Mobile Intel[®] Celeron[®] Processor at 466 MHz, 433 MHz, 400 MHz, 366 MHz, 333 MHz, 300 MHz, and 266 MHz Specification Update

Release Date: November 2001

Order Number: 244444-028

**Specification Update for the Mobile Intel® Celeron®
Processor at 466 MHz, 433 MHz,
400 MHz, 366 MHz, 333 MHz, 300 MHz, and 266 MHz**

Figure 1. An Example of Microcontroller Driven Thermal Management

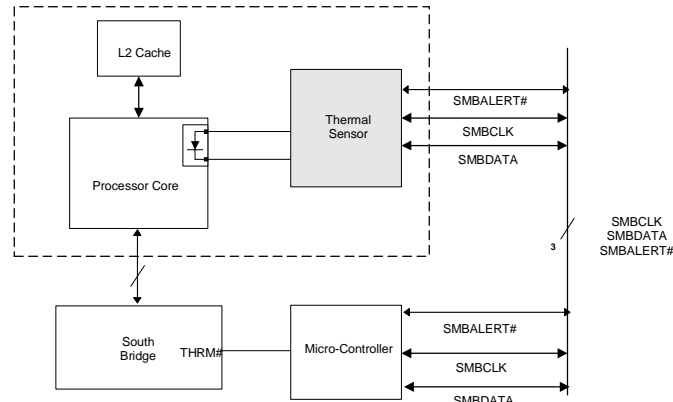
H29. Thermal Sensor May Assert SMBALERT# Incorrectly

Problem: The Intel Celeron Processor Mobile Module has a thermal sensor that monitors the processor core's temperature. Please note that desktop systems could have a similar thermal device. The thermal sensor asserts SMBALERT# if the processor temperature exceeds the temperature limits set in the Alarm Threshold Registers (T_{HIGH} , T_{LOW}). It also sets the corresponding Status Register bits to identify the cause of the interrupt. Figure 1 gives one example of the how the SMBALERT# signal could be used in a system.

Implication: There is no system impact from this erratum if temperature polling is used for processor thermal management. If the SMBALERT# interrupt is employed to manage processor thermal sensing, then servicing the false interrupt may result in premature system action depending on the software and hardware implementations used. The rate of the false interrupts is less than the auto-convert rate of the thermal sensor.

1. Before servicing an interrupt from the thermal sensor, read and compare the processor thermal reading with the threshold limits (T_{HIGH} or T_{LOW}). Figures 2 and 3 provide basic flowcharts for the implementation of this workaround in an interrupt driven system.
2. If the firmware implemented polls the Status Register only, then before taking any action, re-read the temperature register and do a comparison with the alarm threshold limits (T_{HIGH} or T_{LOW}) to determine if the value is actually still within the temperature window.
3. Use a temperature polling scheme to monitor the processor temperature.
